C/00 SC 0	P 0	L 0	# 1	C/ 07 SC 7.1	P 47	L7	# 50
Hajduczenia, Marek	ZTE Corporati	on		Hajduczenia, Marek	ZTE Corporati	on	
SuggestedRemedy	Comment Status X e spelled "Task Force"			change to	Comment Status X ernet in the First Mile (EFM) tas thernet in the First Mile (EFM)		
Scrub the draft accord	ordingly, there are multiple location	ons where this p	oroblem occurs.	SuggestedRemedy			
Proposed Response	Response Status O			Per comment. The Ta	skForce designation was 802.3	Bah	
				Proposed Response	Response Status O		
C/ 00 SC 0 Hajduczenia, Marek	P 0 ZTE Corporati	L 0	# 2	· · ·

C/ 07 SC 7.2 Page 1 of 31 1/22/2010 2:10:30 PM

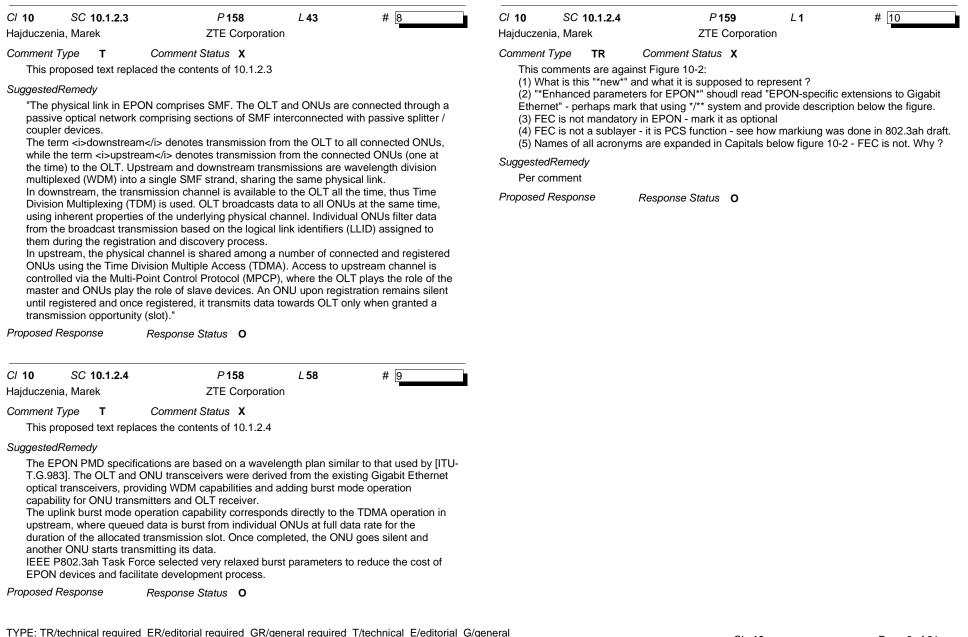
<i>CI</i> 08 Hajduczeni	SC 8.2 a, Marek	P 96 ZTE Corporation	L 44	# 63
Comment 7 Plenty	51	Comment Status X der Figure 8-7 - why ?		
Suggestedl remove	R <i>emedy</i> e this empty space	e		
Proposed F	Response	Response Status 0
